West Burton Solar Project

Environmental Statement Addendum Chapter 14: Transport and Access

PINS reference: EN010132
Document reference: APP/WB6.2.14.1

Figure 14.1: Grid Connection Corridor Access Locations

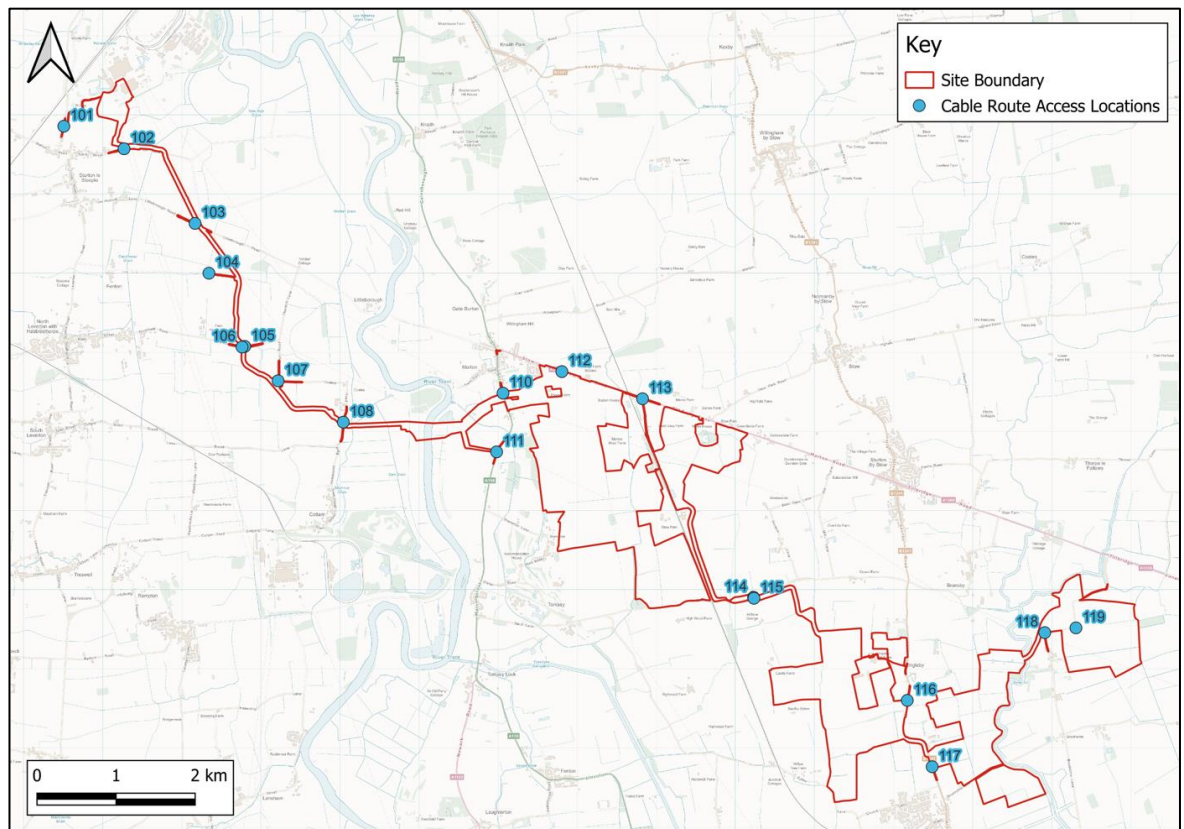
14.2.1 There have been some minor updates to the access locations within the grid connection corridor that are set out in Paragraph 14.7.55 of the ES Chapter 14: Transport and Access **[APP-052]**. The changes have been made to ensure a consistent access strategy with the Gate Burton Scheme, Cottam Scheme and West Burton Scheme for the shared element of the grid connection corridor. All accesses are set out below, with the amendments in bold. Access 109 has been removed:

- Access 101 – Gainsborough Road;
- Access 102 – Common Lane;
- Access 103 – Littleborough Road;
- Access 104 – Three Leys Lane/Fenton Lane;
- Access 105 – Northfield Road (north);
- Access 106 – Northfield Road (south);
- Access 107 – Coates Road;
- Access 108 – Headstead Bank/Coates Road;
- Access 110 – A156 – **relocated slightly to the north;**
- Access 111 – A156;
- Access 112 – A1500 Stow Park Road – **relocated slightly to the west;**
- Access 113 – A1500 Stow Park Road;
- Access 114 – Cowdale Lane (north);
- Access 115 – Cowdale Lane (south);
- Access 116 – Sturton Road;

- Access 117 – Sturton Road;
- Access 118 – Unclassified road south of the A1500; and
- Access 119 – Unclassified road south of the A1500.

14.2.2 The updated access locations are shown in **Figure 14.1** (replacing Figure 14.5 of the ES Chapter 14: Transport and Access [APP-053]).

14.2.3 The minor amendments to the cable route corridor access locations do not change the findings of ES Chapter 14: Transport and Access [APP-053] on the effects of the grid connection corridor, set out in paragraph 14.7.63.
